Production Title	Ng Residence 28 Grassmere Road Killara NSW 2071		
Drawing Title	Garden Concept Plan Michelle and Jonathan Ng		
Designer	Peter Fudge	Director	Peter Fudge
Drawn By	LF	Scale	1:100 on A1
Venue	Peter Fudge Gardens	Drawing No.	Sht-1
Date	06/05/2018	CAD File Name	Ng Plan 2.2
of		one

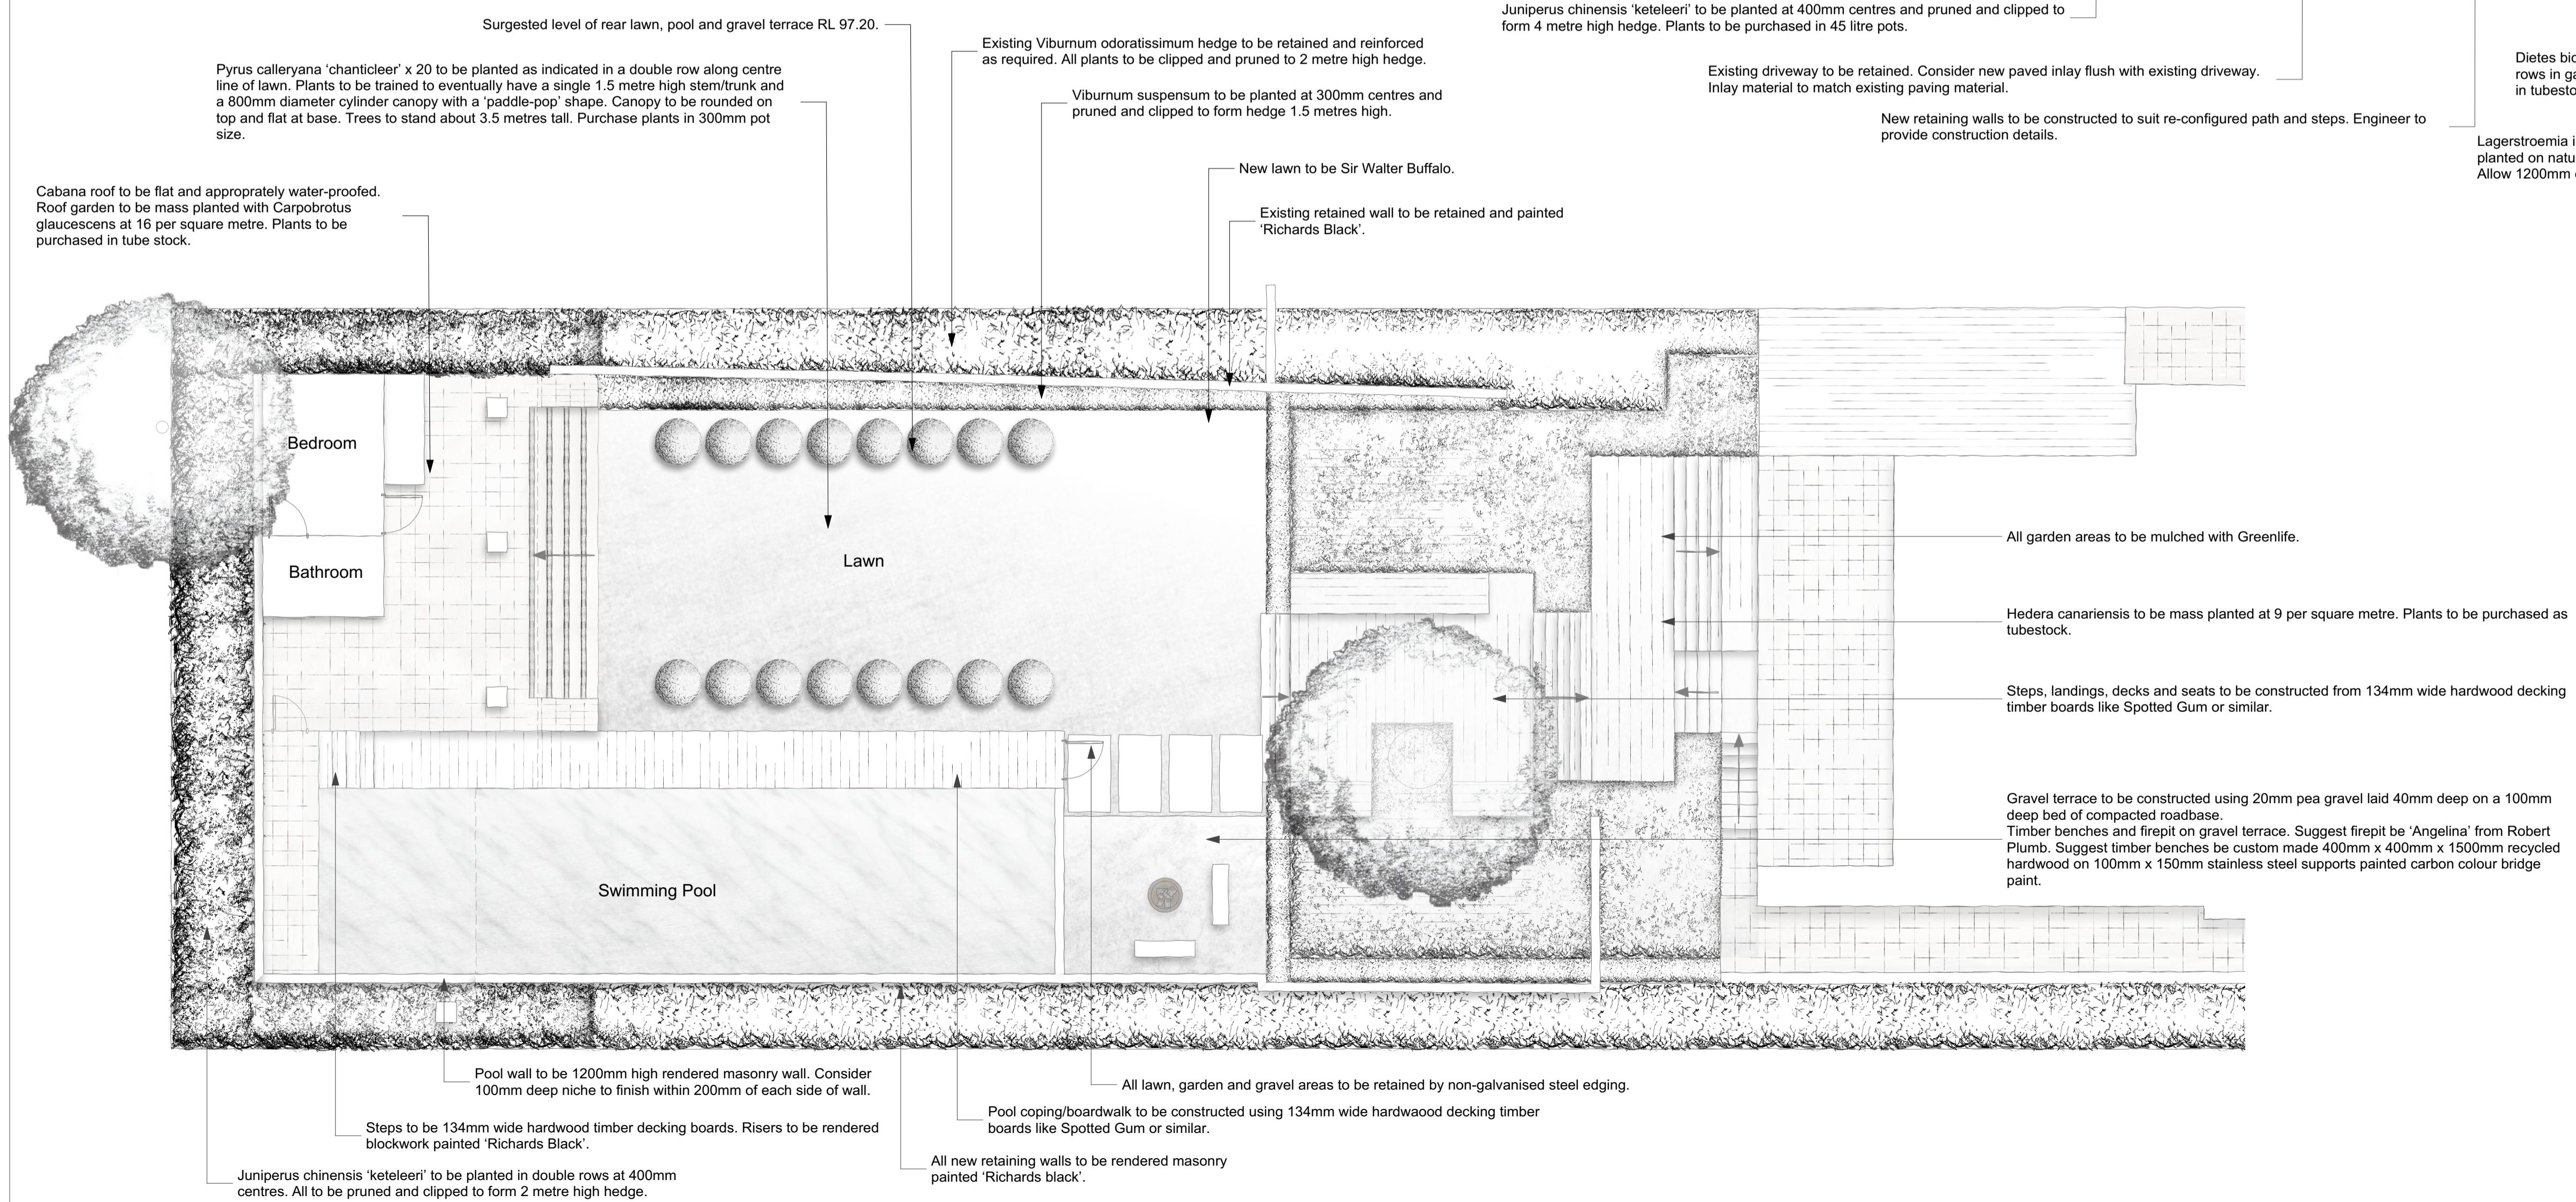
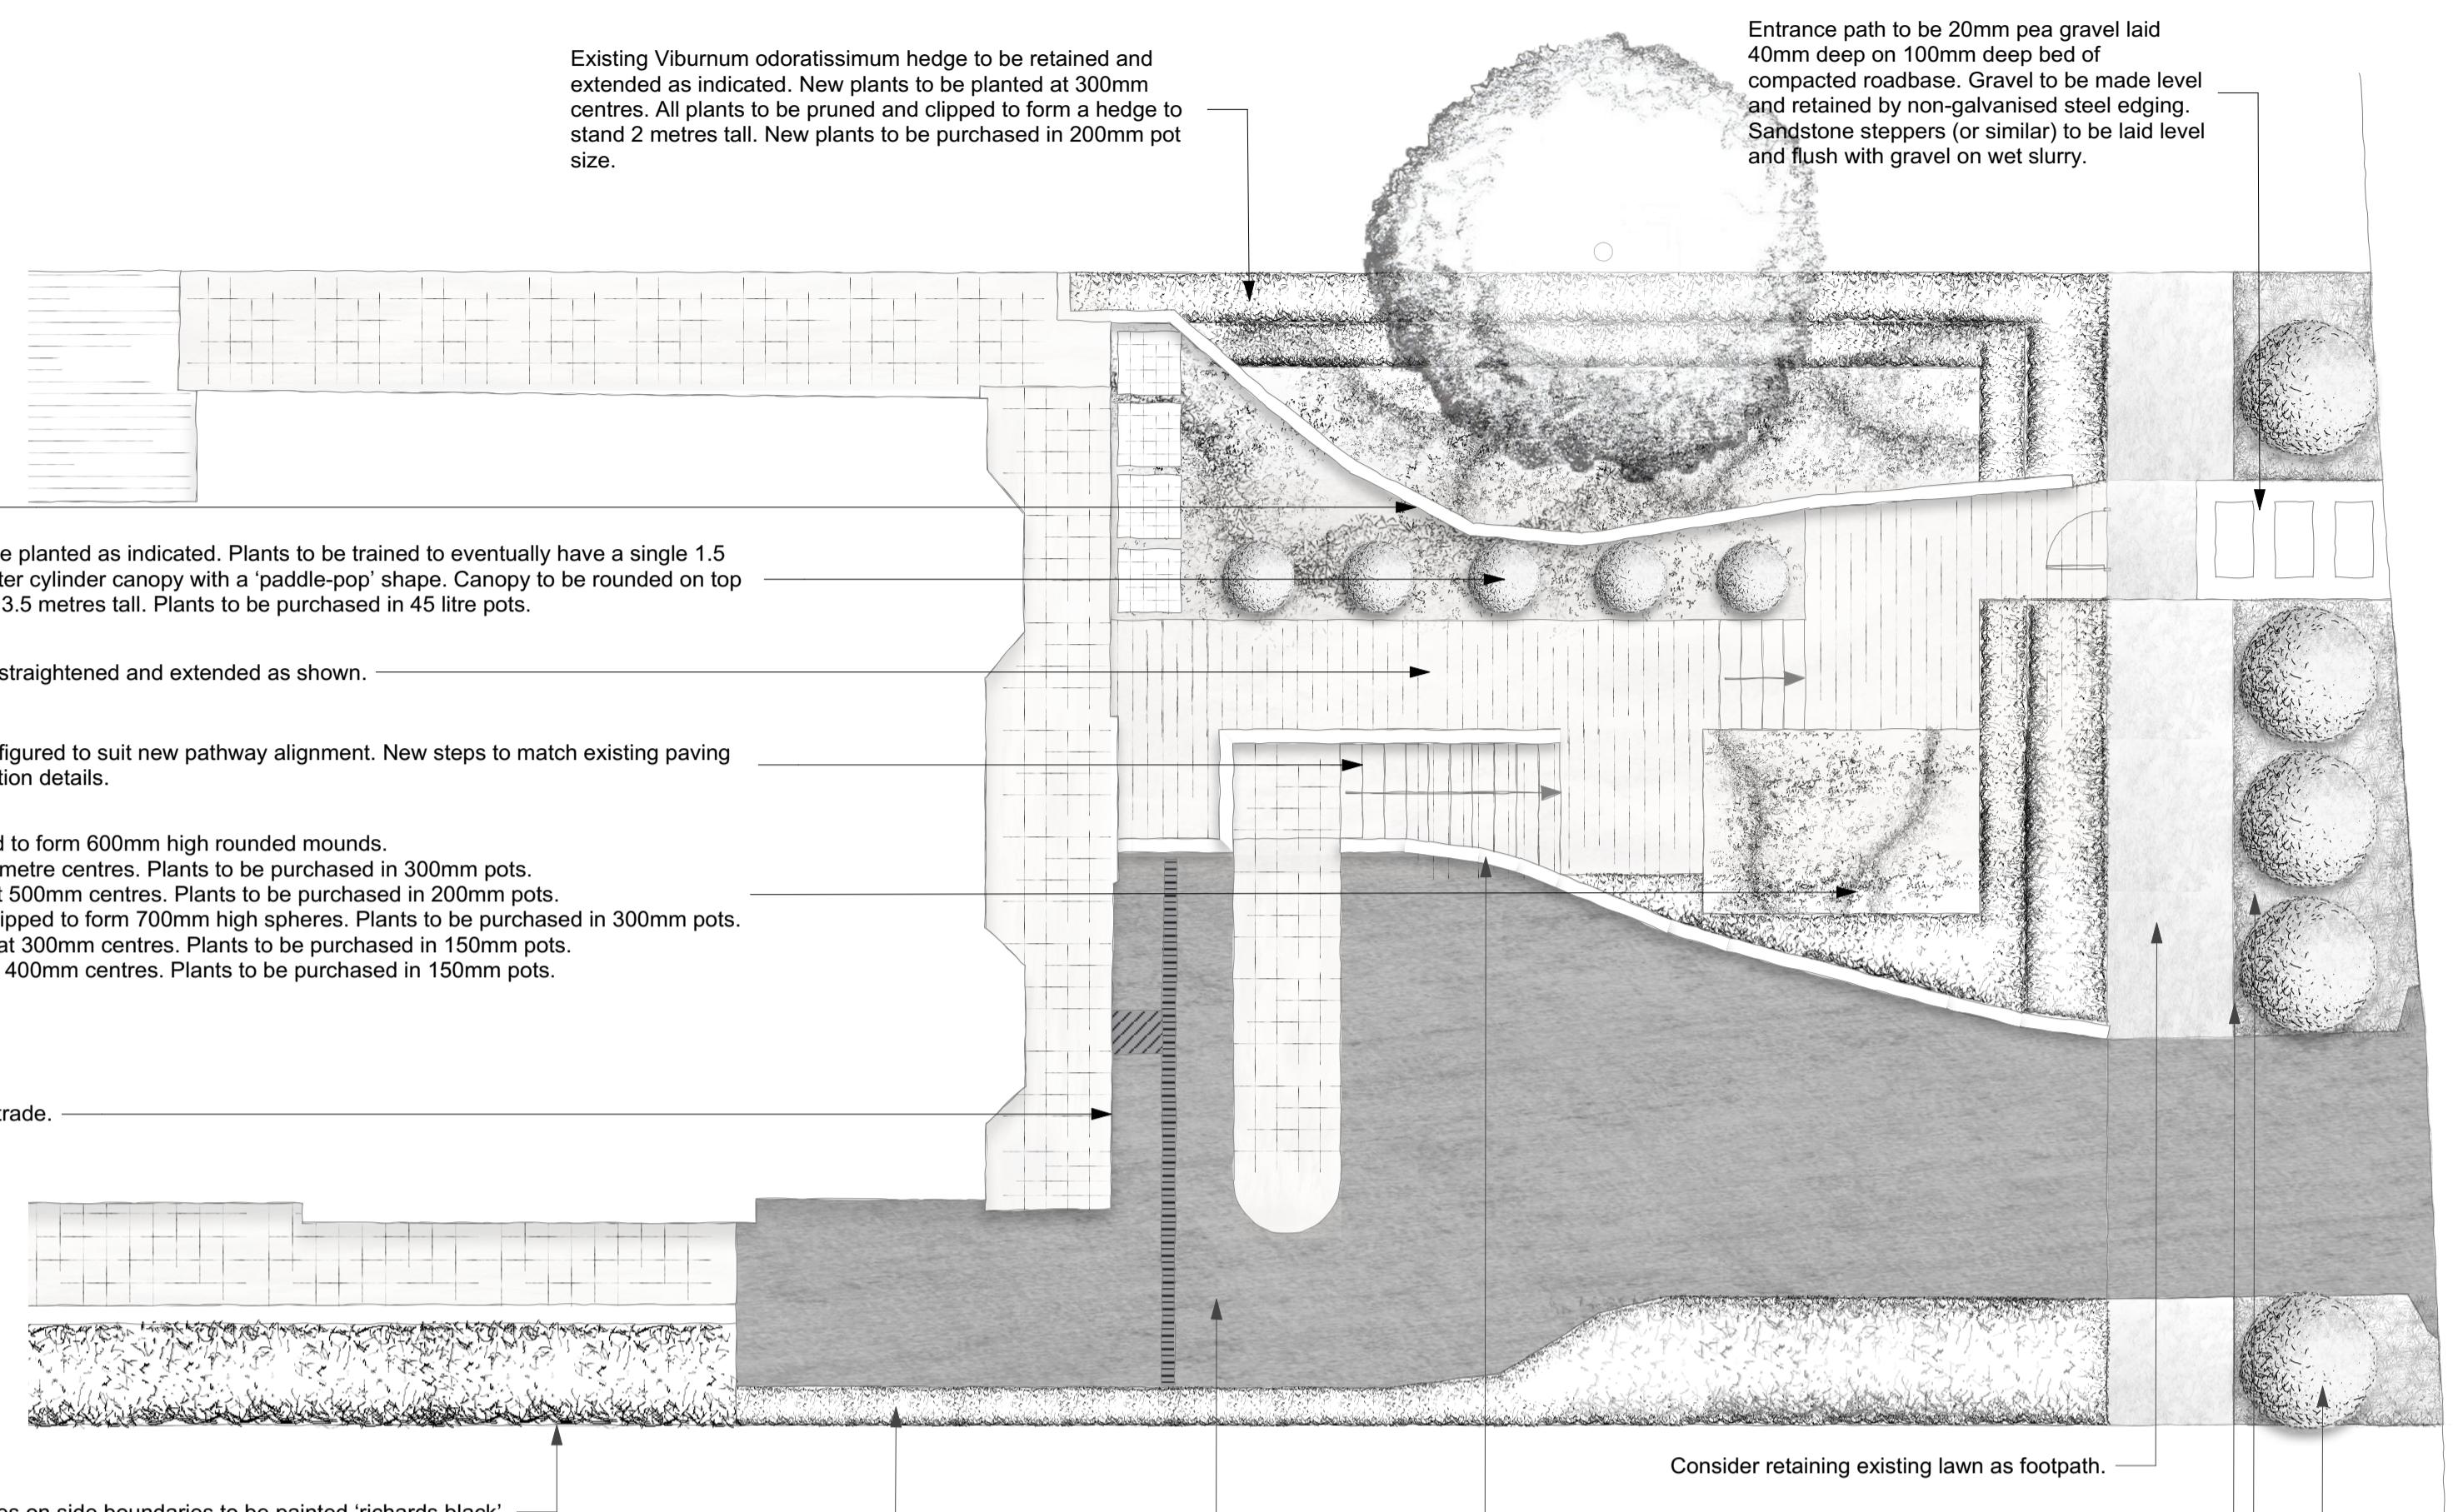
Back
 Steps from verandah btm end of porch and porch centre, 11 steps risers .175 mm ,treads to be 350 mm ?,timber to be hardwood,I use spotted gum, but up to client.
 Jonathan I'm going to ask sc to measure and photo the wall outside the rumpus room and the windows on this part of the house.
 Prune large leaf ivy level at 97 ..
 Pf yet to position this wall but it should have the steps removed from it and a 500 mm bench , 450 mm from the ground, made from boards 100 mm x100mm on 50 mm cubed blocks in st steel, attached block walls every 1.5 m, ie the cubes separate but join the boards to masonry
 Sc is measuring wall outside rumpus room, pf explain to lf long bench
 Make good porch where existing stairs once they've been replaced by new stairs vs hedge at end start of lawn to be 800 mm high
 Two brown walls around gravel area to be rl 97.20
 Widen pavers to side of the lawn, but have to be 1200 mm from fence.

Arrows up all steps
 Darker graphic for Jck
 Lee, put bedroom and bathroom behind kitchen wall , arch how far off bound ,Jonathan council probably won't let you do this?
 Lee , add RLs of walls mlawn (?type is soft leaf buffalo),Eucalyptus saligna,new steps ,RLs on deck under tree
 Balustrade to match existing to flank steps from porch
 Pool fence frameless glass on spiggets .heater and filter see me
 Poolmsteps see me,deep end vs shallow end see me.
 Show Metal edging around vo s (existing) ie say this,steppers,
 All paving.....
 Put my notes on plan and A 4
 See re design of side garden x 2
Front
 Show boardwalk steps,it's a walk not paved,landing 1 step lower the verandah,reverse stair from drive therefore paved inlay
 Show ss from bulk to side of house,jck adjacent to porch,show existing wall around euc.
 Jonathan did the owners or council ever give you conditions re the 2 trees?
 Show where existing vos stop (this influences plant schedule) plant up to front gate,
